RECEIPT DATE: 5/7/19 **ONSITE SEWAGE DISPOSAL SYSTEM** P 565479

**RE:** 5328 Catalpa Court  
Walnut Creek, Lot 92

The OSDS Plan for 5328 Catalpa Court has been reviewed with the following comments:

**SEPTIC SYSTEM  
INSTALLATION SITE PLAN  
WALNUT CREEK  
PHASE THREE  
Lot 92**

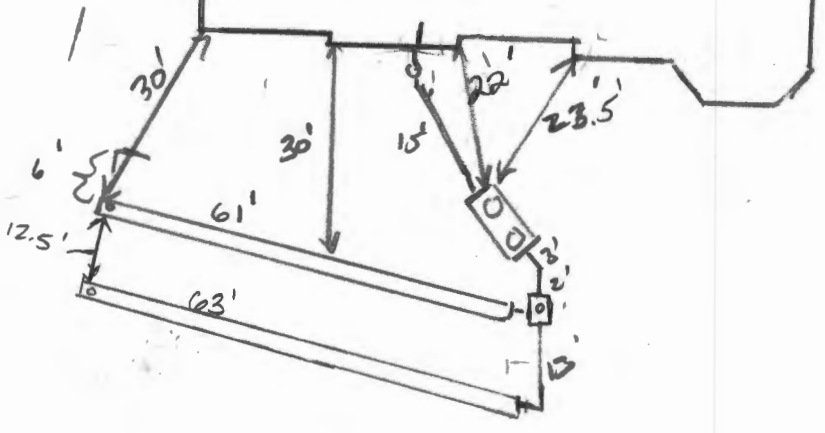
HO-95-26-10  
\*WELL IS IN FRONT OF HOUSE, NOT AS SHOWN...

7/26/19 Contour shot in field. Elevations run straight/parallel w/ top of SAA. Install 2 x 62' trenches on contour. Set septic tank per plan. OK to turn tank slightly towards start of upper trench. (Kor)

INSTALLATION: 7/29/19 SNG made. Tank sets. Upper trench complete. Dbox set per plan. Lower trench started. OK to center. (Kor)

7/30/19 Dbox LEVELED w/ SPEED LEVELS. LOWER TRENCH COMPLETE. OK TO BACKFILL - BAFFLES INSTALLED. (Kor)

**SEPTIC PROFILE**  
SCALE: 1" = 30'

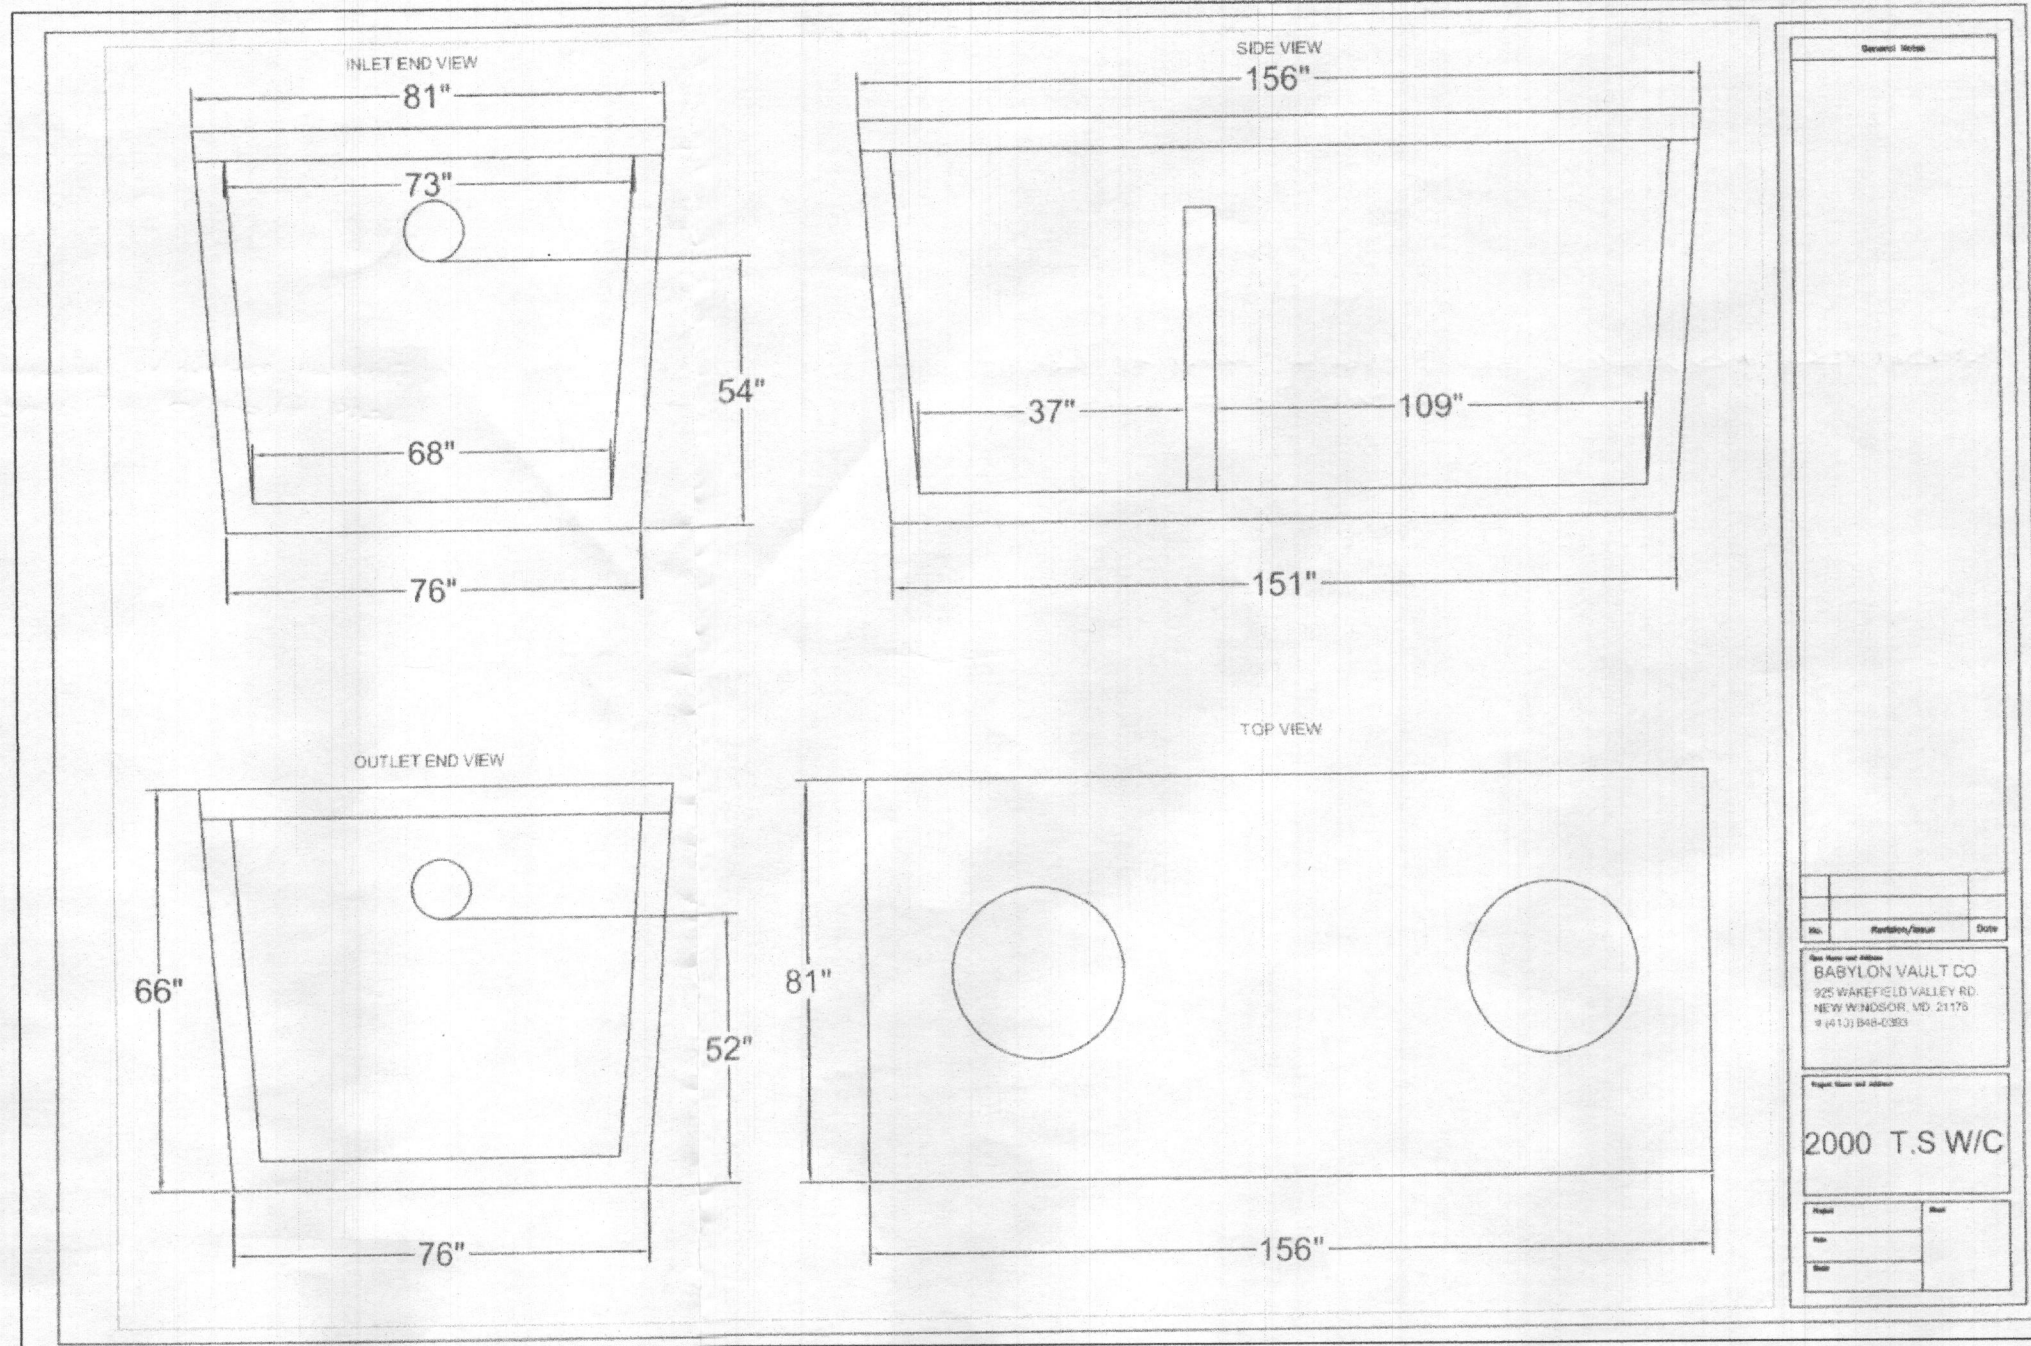
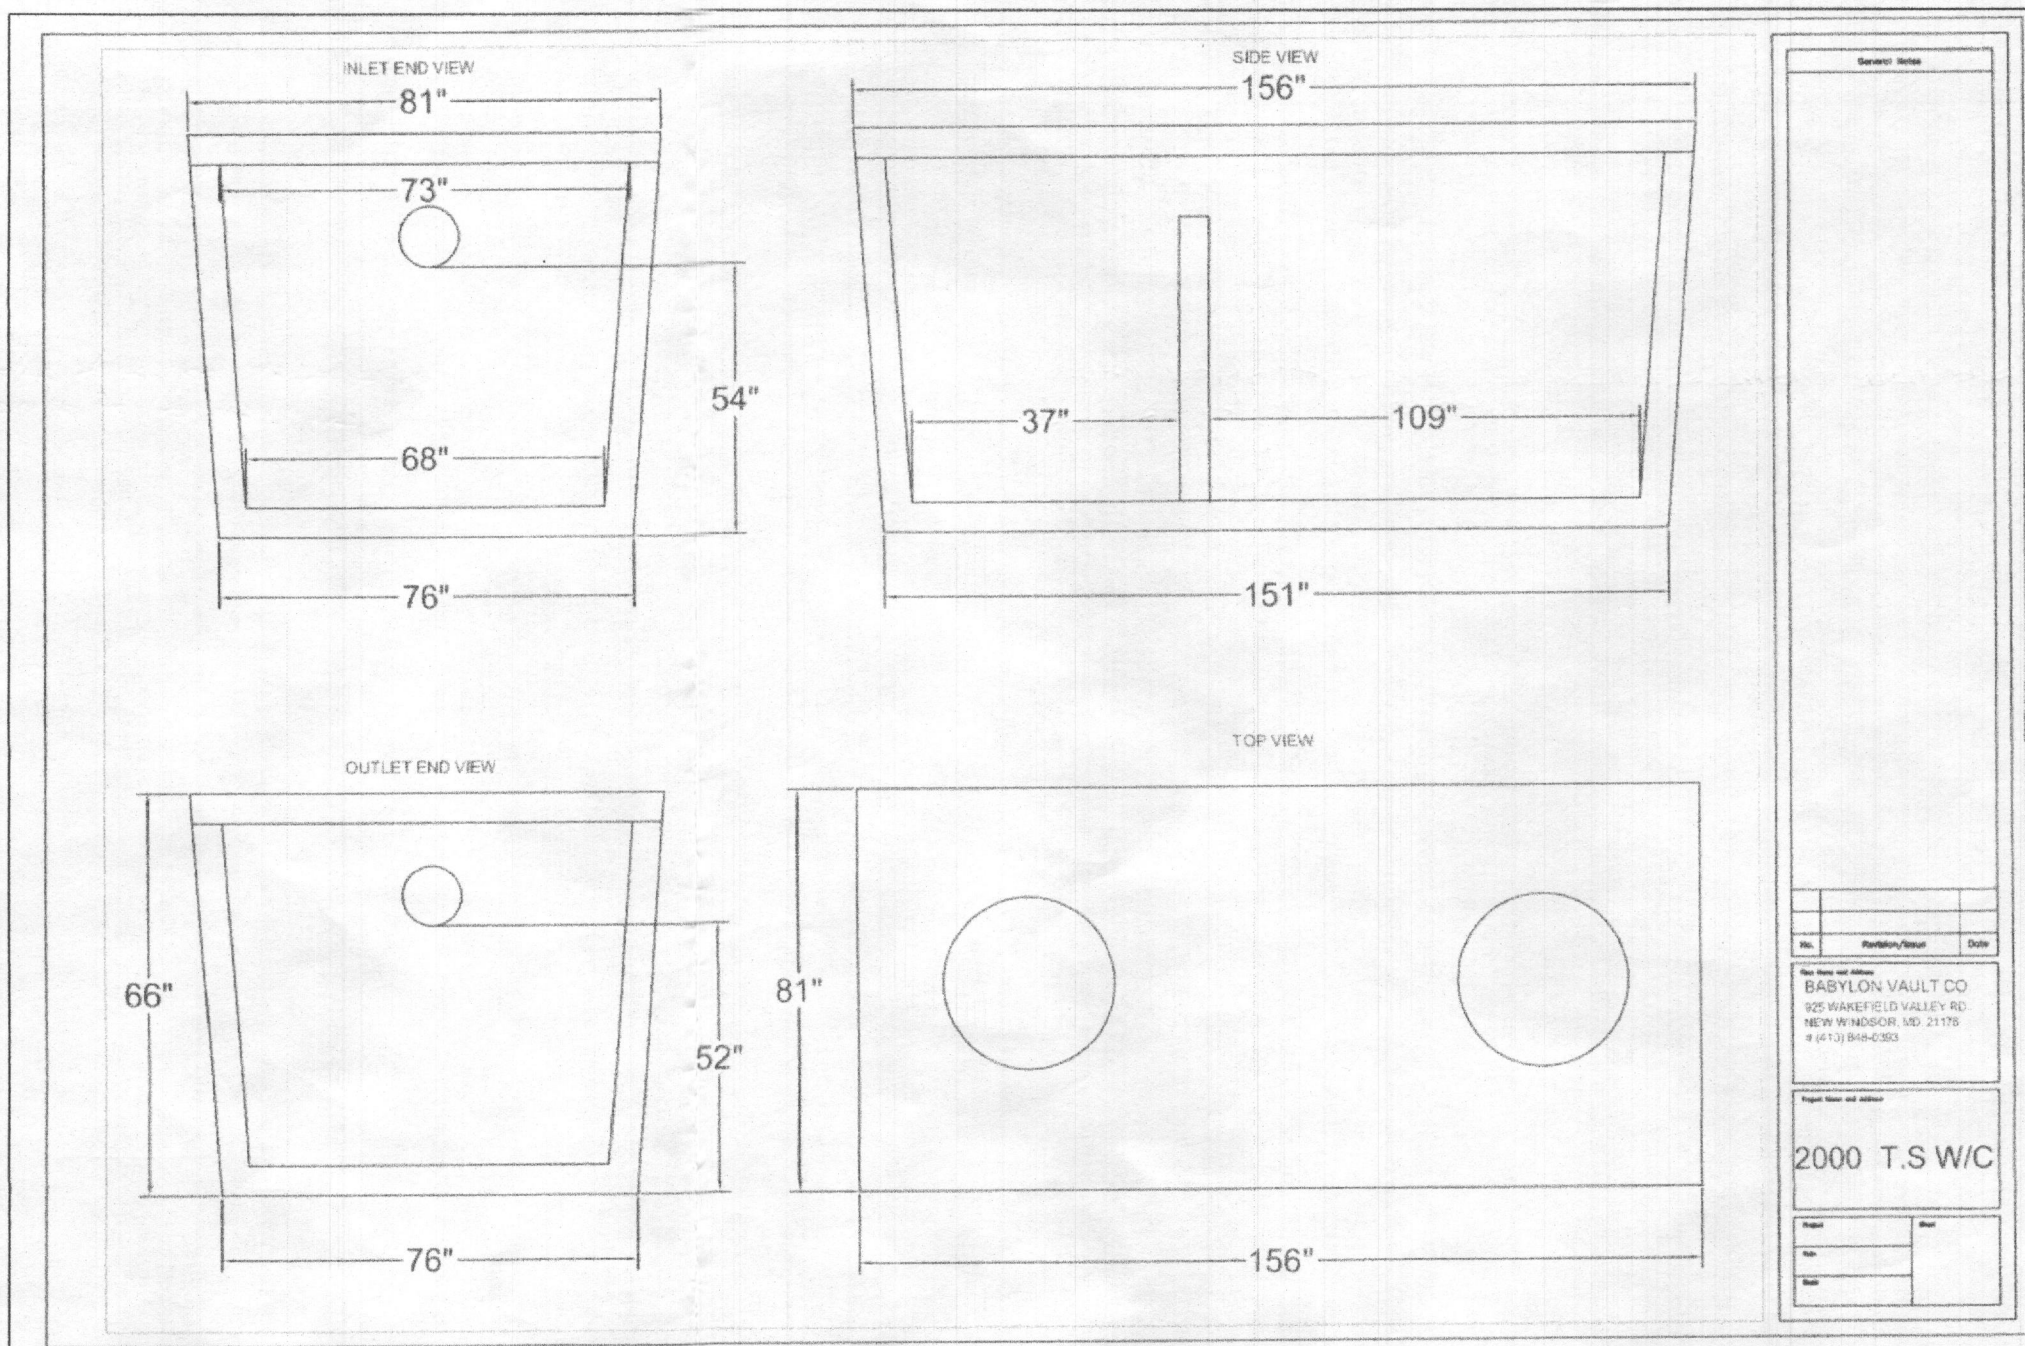
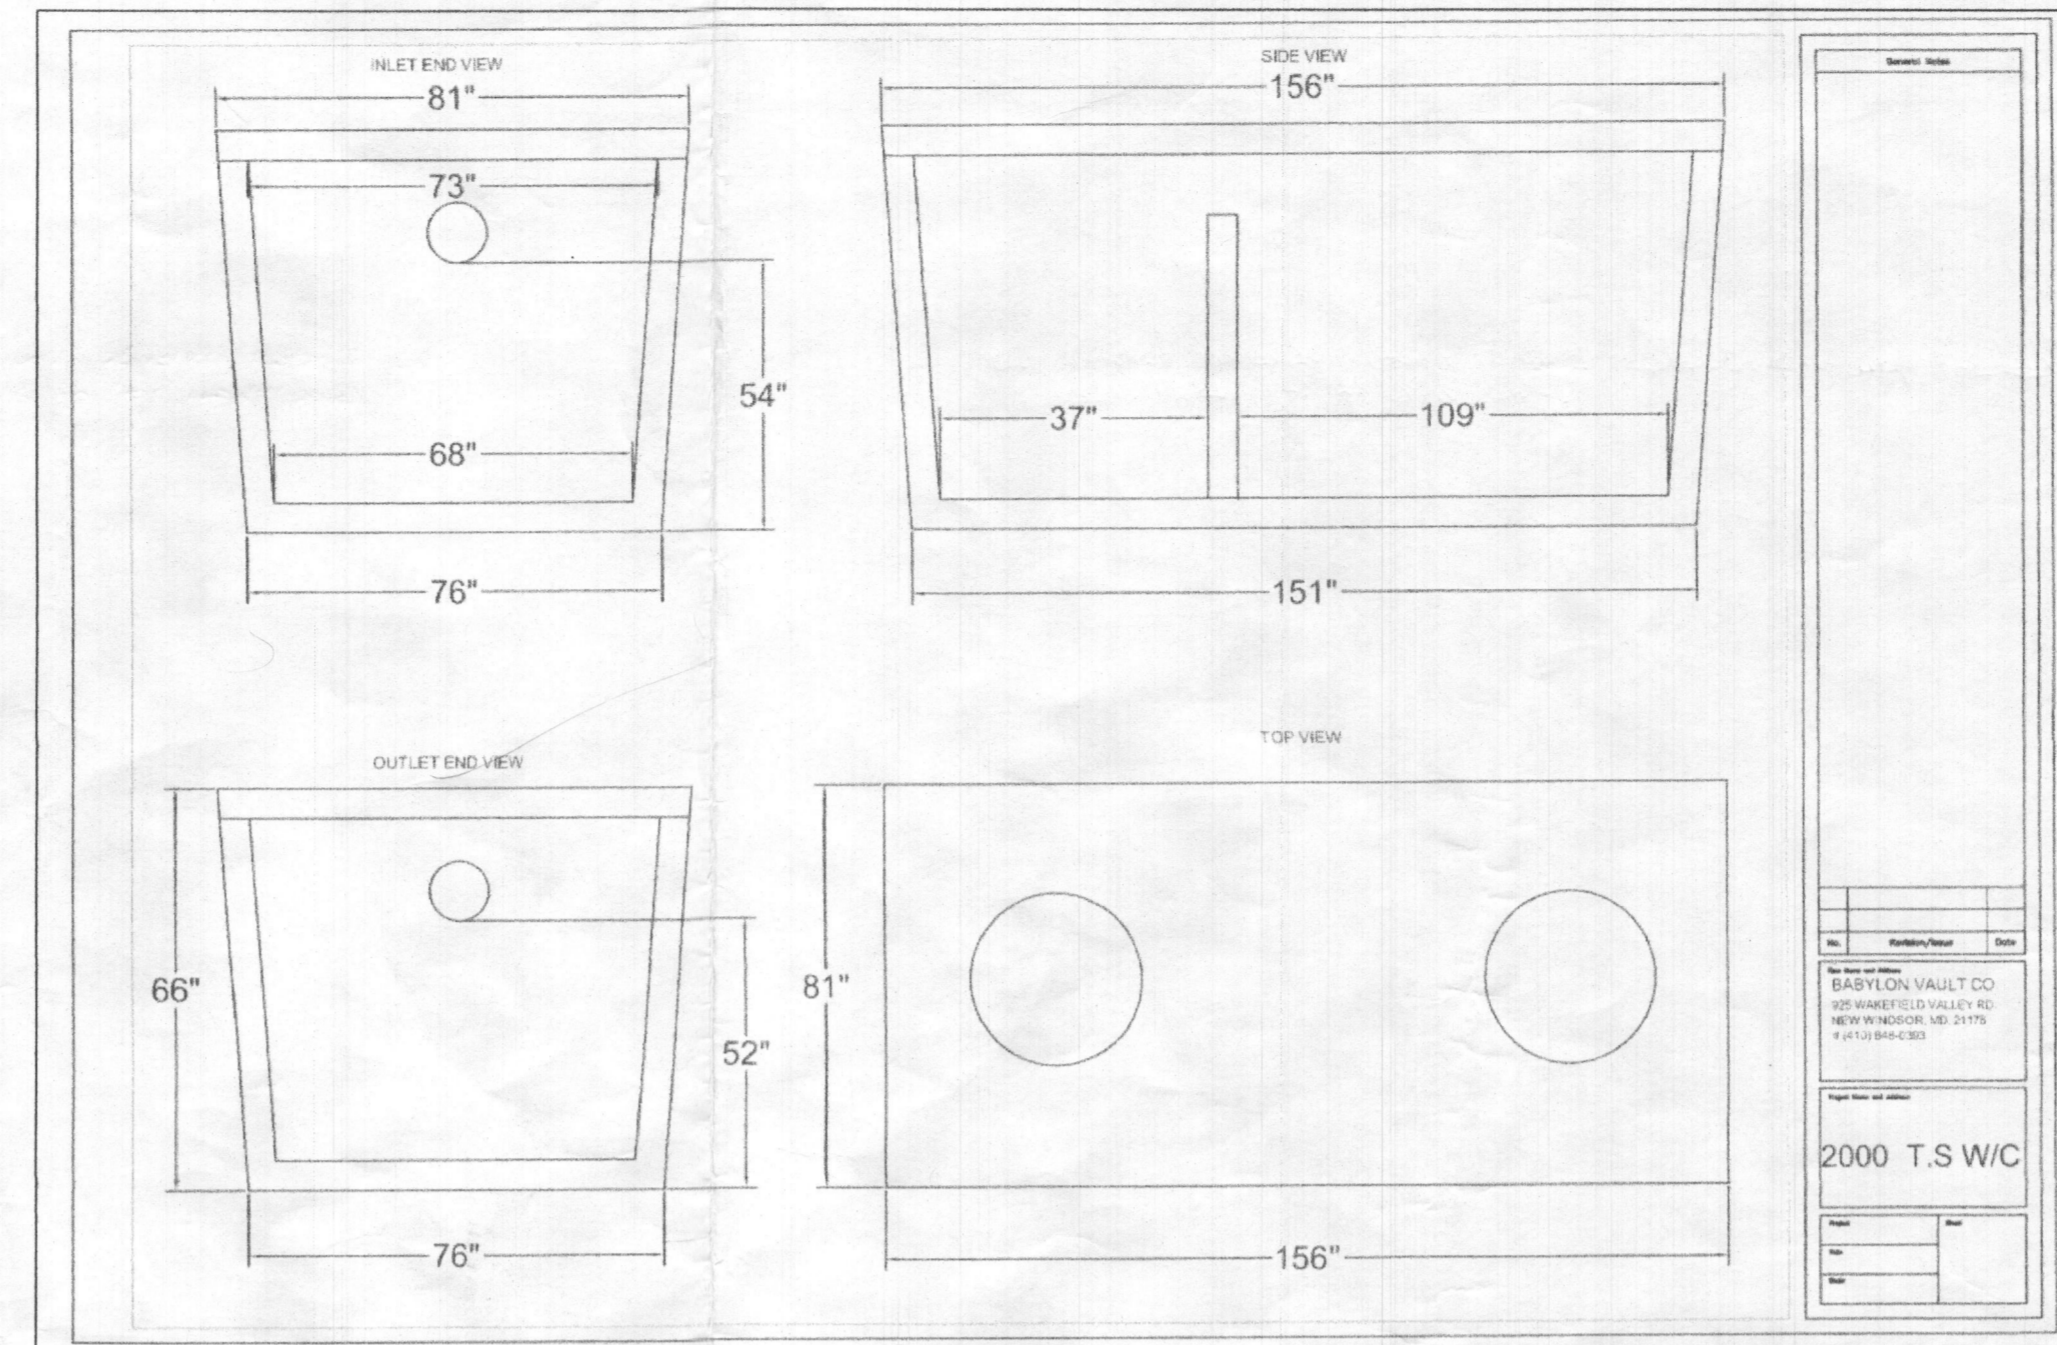
- 1.) Show sidewall at 4 feet and bottom of trench at 8 feet in calculations. ✓
- 2.) Show trench spacing at  $2D+W = 2(4) + 3 = 11$  feet. ✓
- 3.) Change proposed grade over tank to 3 feet or less. ✓
- 4.) Change initial trench detail to show trench invert at 4 feet (or less) and a max bottom depth of 8 feet. ✓
- 5.) Increase pipe length (as much as possible) between last cleanout and tank. ✓
- 6.) Show sanitary tees "sweeping tee" at top and bottom of cleanouts before tank. ✓
- 7.) Improve trench labeling in layout. ✓
